Groundwater Transfer Review Summary Form

Transfer/PA # T- 14661

Application: T-14661

Applicant Name: Dinsdale Farm & Equipment LLC

Figure 1: Drawdown simulation for Certificate 61539 using hydraulic parameters from McFarland & Ryals, 1991

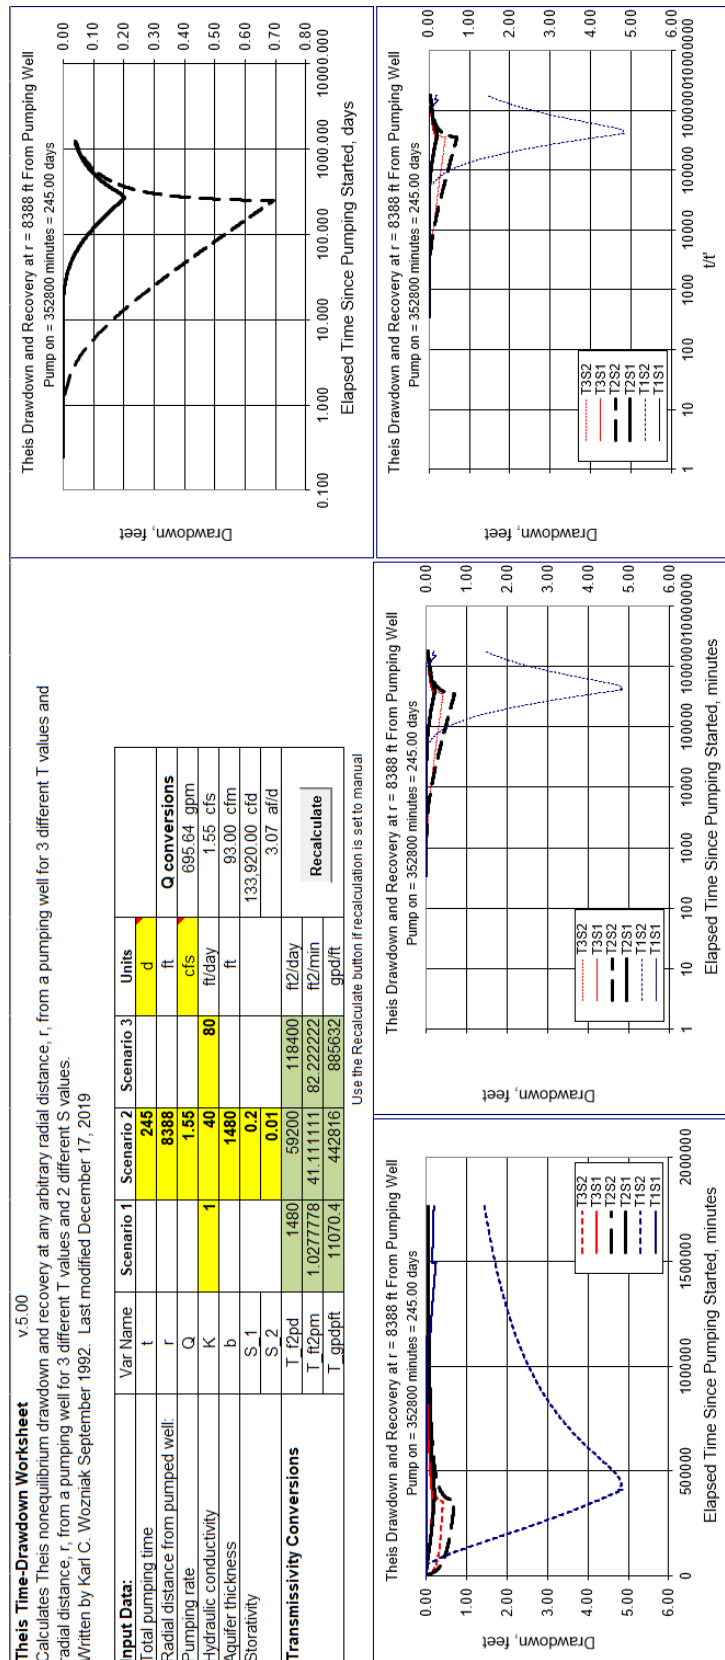
Assuming constant use at max rate for 245 days, the drawdown associated would likely result in marginal increases in drawdown for Certificates 92116, 47722, 61539, and 61538 since the To-POA is moving closer to the POAs for those certificates. Using the most conservative parameters, simulated increase in drawdowns associated with this change in POA will be less than 0.1 ft. LAKE 504 shows a record of measurements from 1985 to 2017 with a 0.4 ft/yr decline. Additionally, the To-POA will only be located 50 ft east of the existing From-POA, so increased impact to nearby wells should be minimal with a very low risk of injury. Hydraulic parameters used in drawdown analysis taken from McFarland and Ryals (1991).

☐ Yes ☒ No If yes, explain: _____

Figure 3: Map of Application T-14661

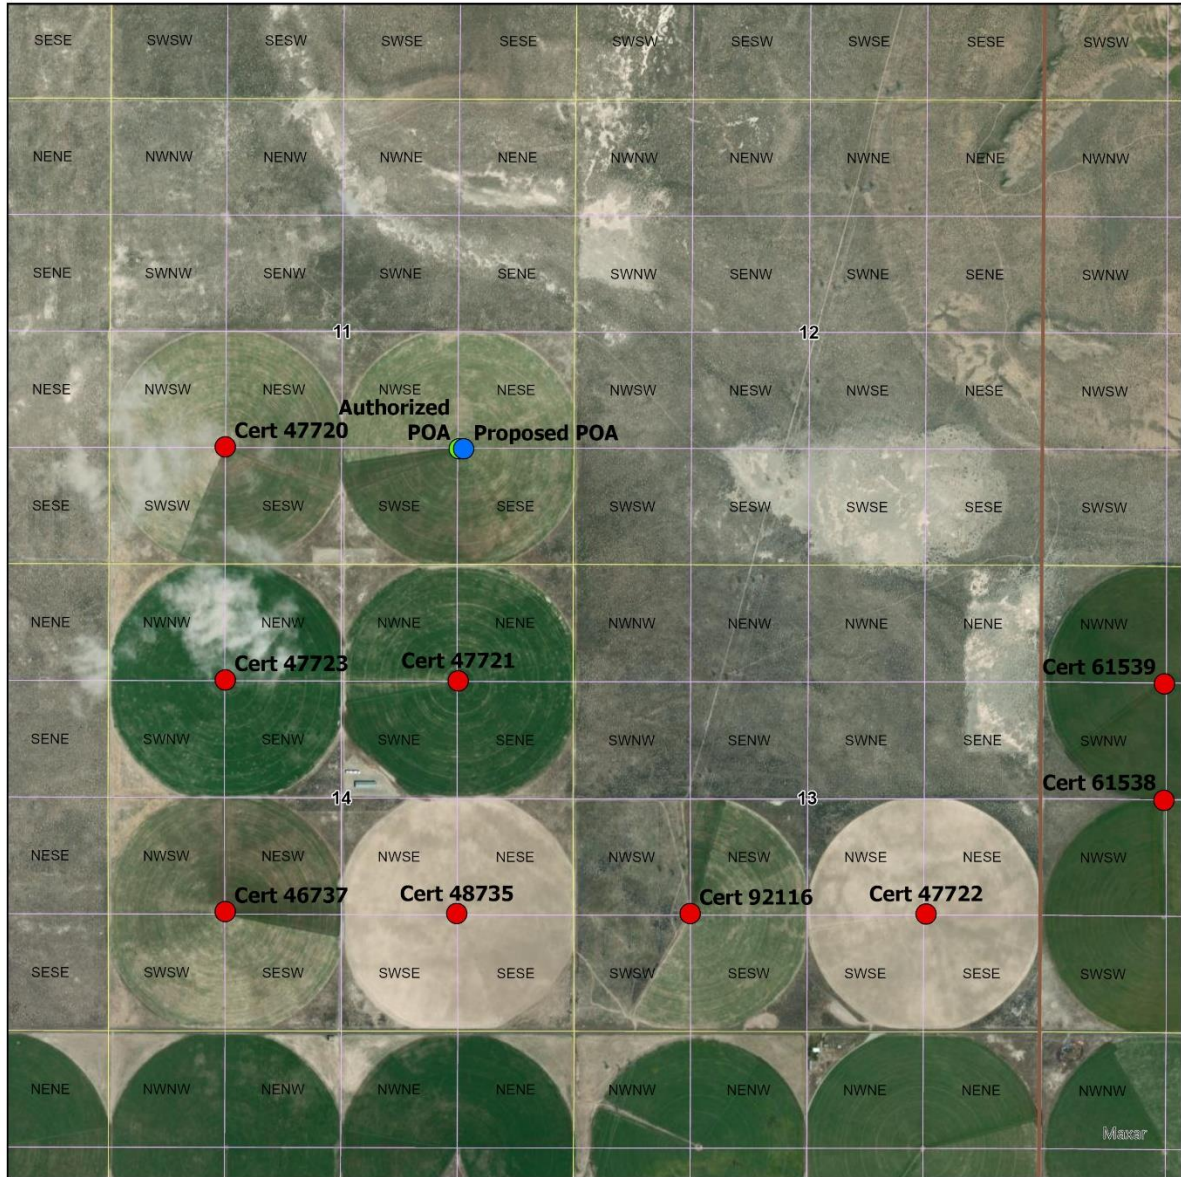
☒ Yes ☐ No Comments: To-POA is moving further away from wells Certificate 47720, 47721, and 47723 POAs. To-POA is moving closer to Certificate 47722, 92116, 61539, and 61538 POAs. The applicant is the landowner associated with Certificates 47720, 47721, 47723, 47722, and 92116.

From-POA is 5891 ft and To-POA is 5867 ft away from Certificate 92116 POA. From POA is 7478 ft and To-POA is 7442 away from Certificate 47722 POA. From-POA is 8437 and To-POA is 8388 ft from Certificate 61539 POA. From-POA is 8937 ft and To-POA is 8895 ft from Certificate 61538 POA.
